CROW BUTTE RESOURCES, INC.

Re: Docket No. 40-8943
License No. SUA-1534
Annual Report of Changes, Tests, or Experiments

2002 SERP Evaluation Index

Figure 5.1-1: Crow Butte Resources Organizational Chart

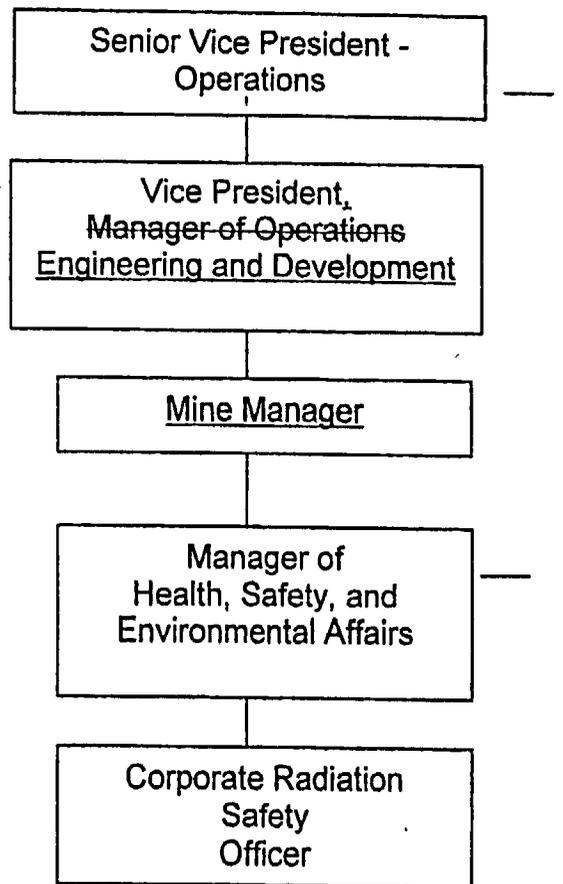
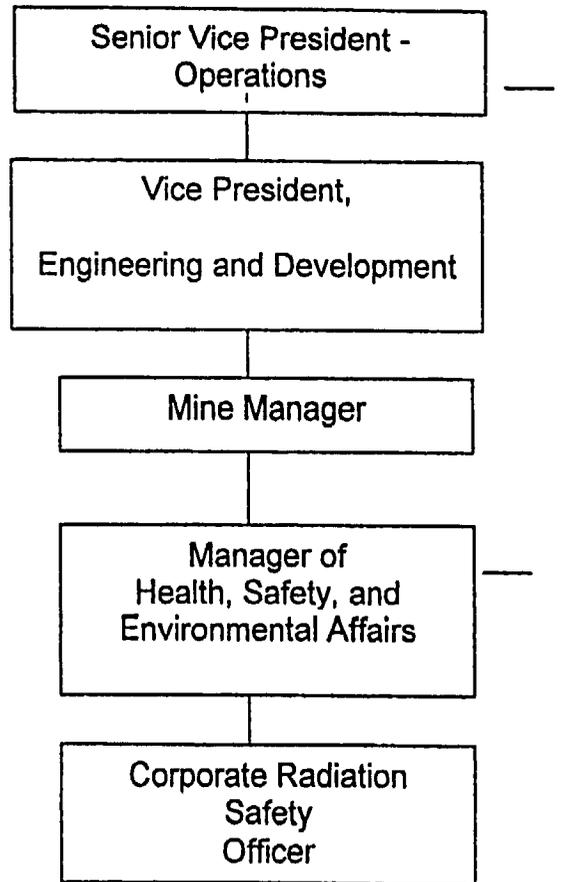
The purpose of the SERP evaluation was to review a proposed organizational change affecting the reporting responsibilities of the radiation safety staff. Specifically, the Corporate Radiation Safety Officer (CRSO) reports to the Manager of Health, Safety and Environmental Affairs as shown in the current organizational chart included as Figure 5.1-1 from the approved application (revised page dated April 6, 2001 attached). The Manager of Health, Safety, and Environmental Affairs reports to the Senior Vice President in the current organizational chart.

Section 2.1 of Regulatory Guide 8.31 states "generally, the RSO should report directly to the resident manager on matters of radiation safety." The proposed organizational change results in the CRSO and the radiation safety staff reporting to the Mine Manager through the Manager of Health, Safety, and Environmental Affairs.

It was the conclusion of the SERP that the proposed change is allowed by License SUA-1534 and should be approved. The revised pages of the license application (pages 5-1 through 5-3) required in accordance with License Condition 9.4 were reviewed and approved and are attached to this evaluation.
